Selsey East Beach Harbour – Selsey Haven

Updated advice following ‘Alternative Layout’ from Royal Haskoning DHV.

Annex A - Further information provided by RHDHV

Alternative Layout (Aug 2017)

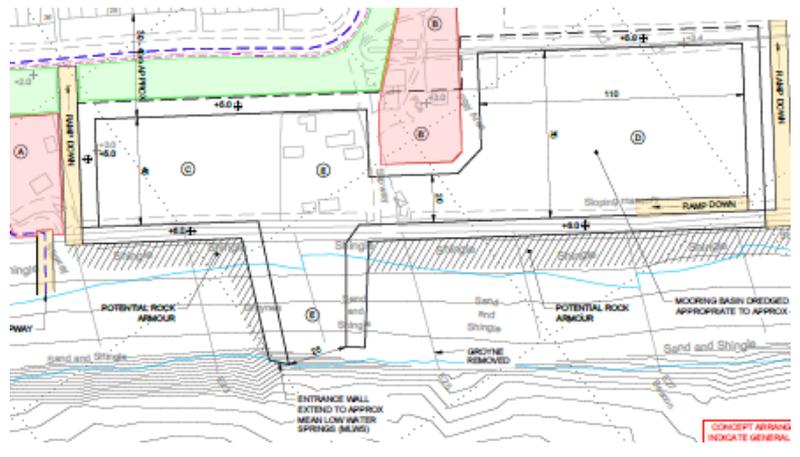
4. It is appreciated that the aim is for the harbour arms *‘to act just like the current groyne system does, therefore minimising the impact on sediment transport.’* However the current groyne field is wooden groynes with relatively uniform spacing. This scheme would effectively place two larger (height and width(?)) solid rock(?) groynes. This would have a greater effect on the system than the wooden groynes currently have, thus reducing the potential for longshore sediment transport.

5. Compounding the effect of disturbing longshore sediment movement is the inlet itself, previously mentioned in point 21 of the geomorphology comments (25 May 2017). Whilst the impact with inlets causing a change and or break in the sediment transport system could be subject to additional studies and numerical modelling. Anecdotal evidence from other harbours on this stretch of coastline would indicate (for example) tidal flushing to be a likely effect, causing complexities when considering the bypassing of sediment.

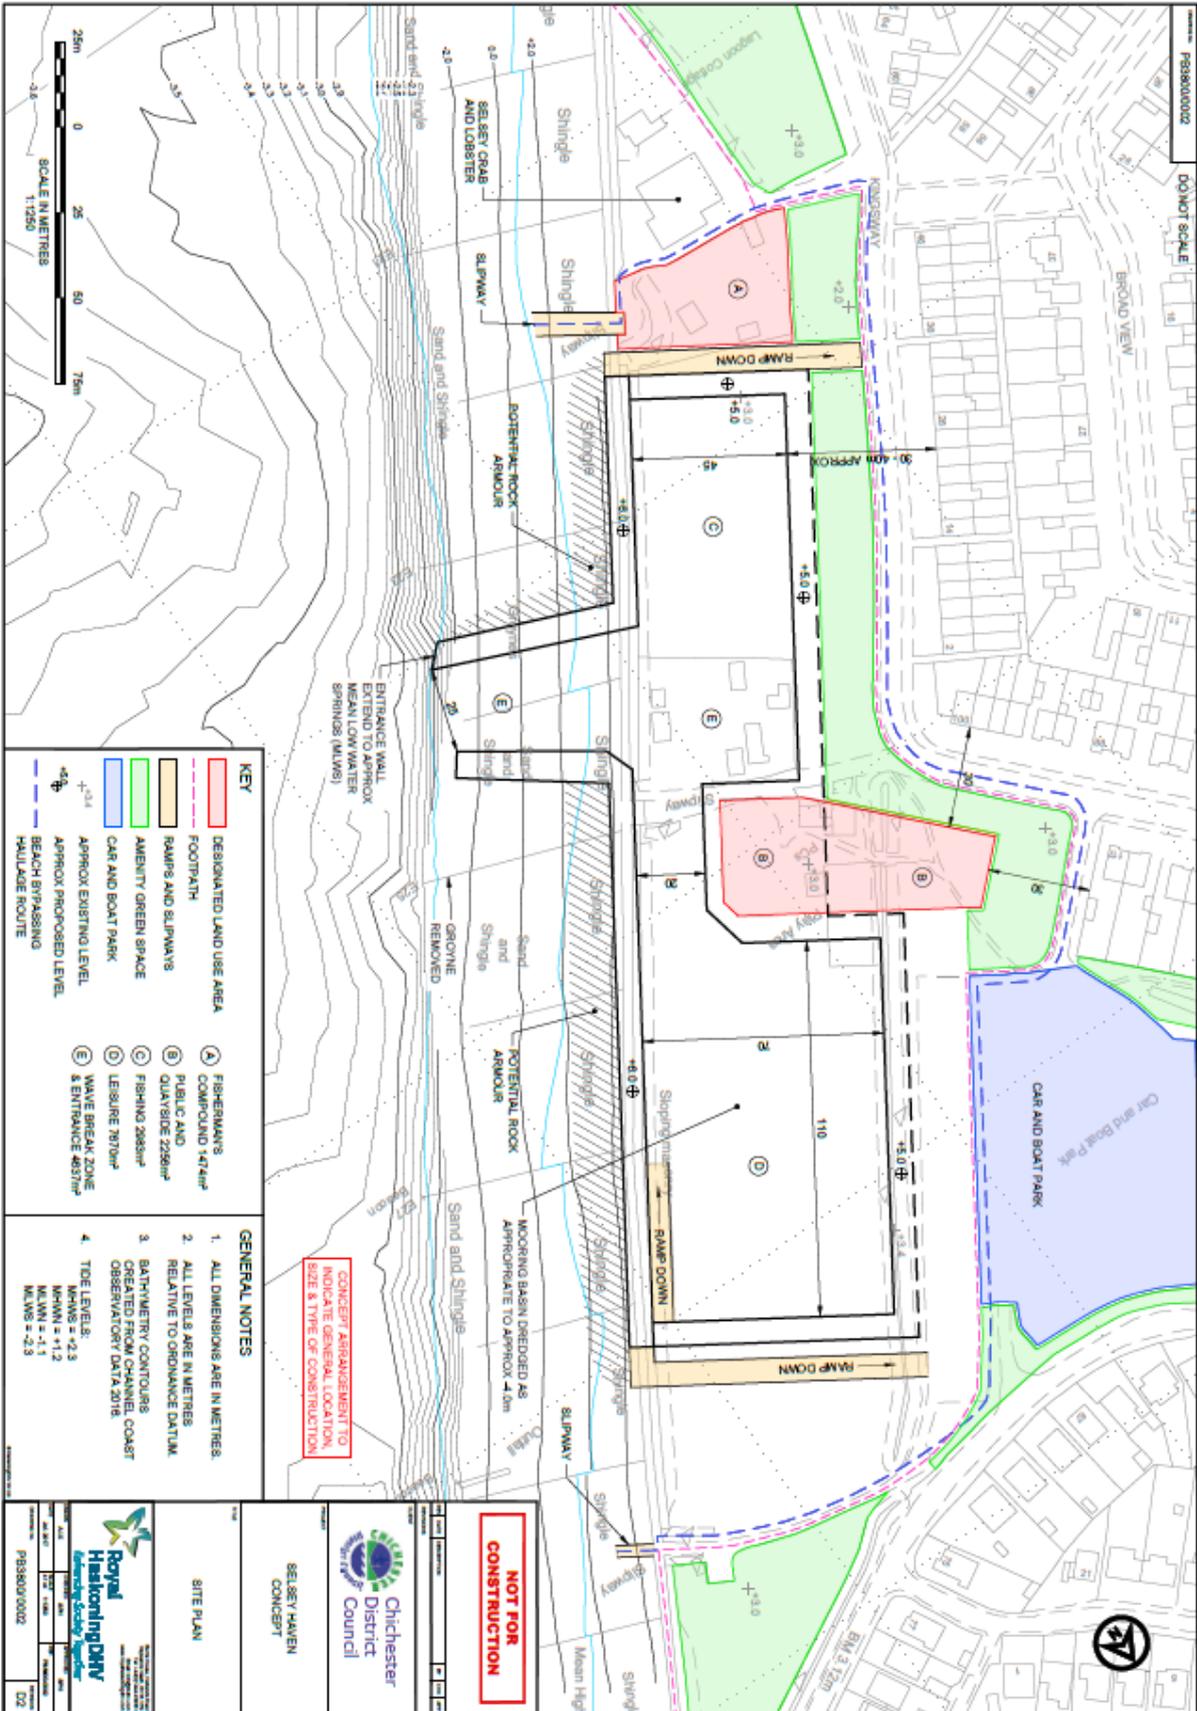
- that for this option, the concept is for the harbour arms to act just like the current groyne system does, therefore minimising the impact on sediment transport.
- Sediment will be bypassed and dredged from the harbour entrance as required, in order to maintain the 'natural' sediment transport, therefore the sediment transport process will be managed to mimic as far as possible the variability in the transport rates through a process of monitoring and adaptive bypassing.
- Beach bypassing would still form an integral part of the design which will accommodate works to facilitate the by-passing operation.
- Additional studies, numerical modelling etc. will follow this process.
